From: Hoban, John: PC-Plan ["/o=exchange/ou=town hall/cn=recipients/cn=plnjeh"]
Sent: 29/09/2014 15:04:47
To: soconnor@rydon.co.uk
CC: slawrence@rydon.co.uk
Subject: FW: Grenfell Tower, Grenfell Road, Refurbishment - Fire Strategy P2

The Building Regulations 2010 [as amended]
Grenfell Tower, Grenfell Road. London. W11.

From: John.Hoban@rbkc.gov.uk [mailto:John.Hoban@rbkc.gov.uk]
Sent: 31 December 2013 11:57
To: Bruce Sounes
Cc: Paul.Hanson@rbkc.gov.uk
Subject: Grenfell Tower, Grenfell Road, Refurbishment - Fire Strategy P2

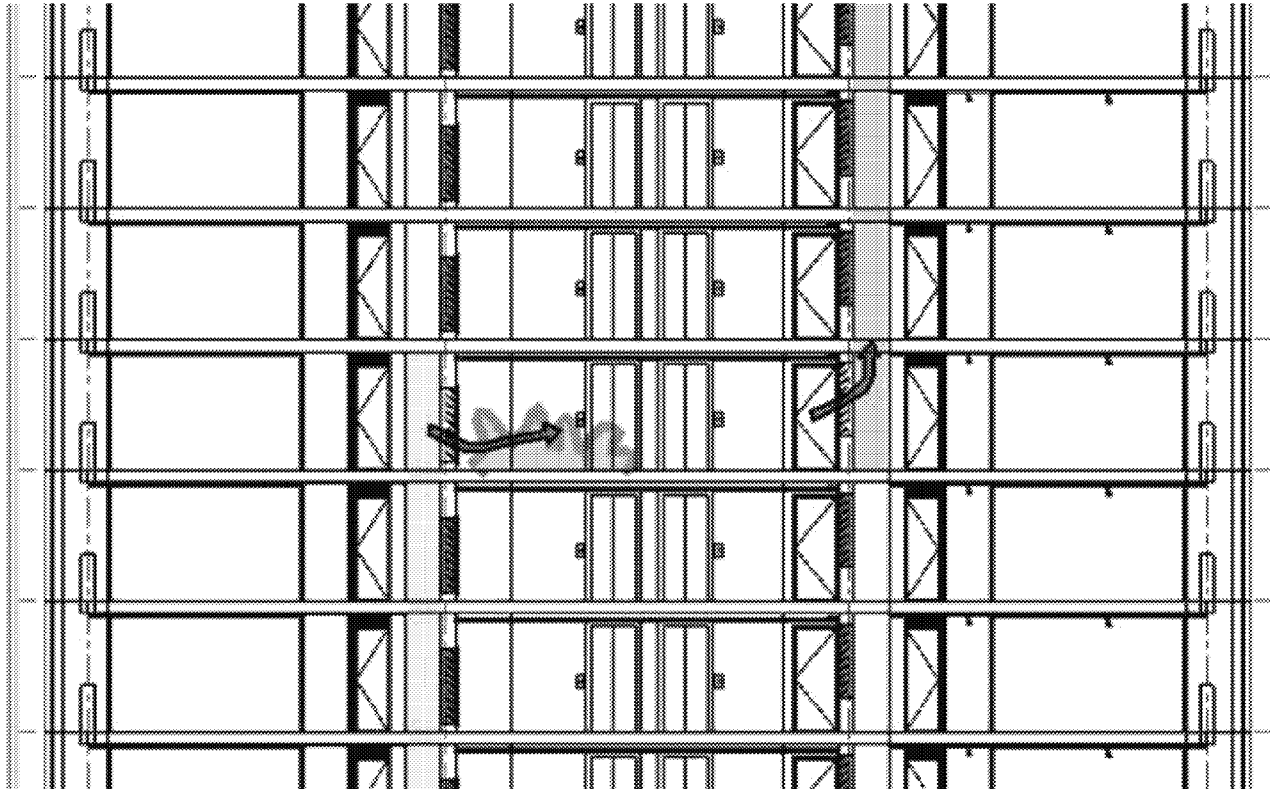
1. "...is designed .. as a natural ventilation system..." (line 2) is followed by "a mechanical supply and extract system which does not rely on natural ventilation" (Smoke Control, second para). His initial response is that this reads like we are omitting a compliant natural vent shaft. We could just leave the 'compliant' system as it is at present, but we (and Exova) think it would

2. Some diagrams would be useful. I have attached our schematic drawing and Studio E have provided the visual representation below.

3. Principle of dual use of duct for vent and smoke okay – but not clear from document and would like some detail as to how this will be achieved.

be better to provide a more predictable system with mechanical supply and extract as the default mode, as described in the 'Proposed System' part of our report.

The smoke controls and the temperature controls would all be part of the same control system controlling the dampers and the supply and extract fans.

Under normal conditions, all the dampers would be open and the system would operate as a natural ventilation system. Temperature sensors would be located on 'typical' (say 5 No.) lobbies. If the temperature in any of these areas exceeded a pre-set comfort level, then the supply and extract fans would operate to try to reduce the temperature.

In the event of smoke being detected within any lift lobby served by the smoke control system, the fresh air and smoke dampers serving that particular lobby would remain open and the supply and extract fans would operate. The fresh air and smoke dampers on all other levels would be closed. The system would be set up such that it was 'fail-safe' with priority always being given to the fire safety operation.
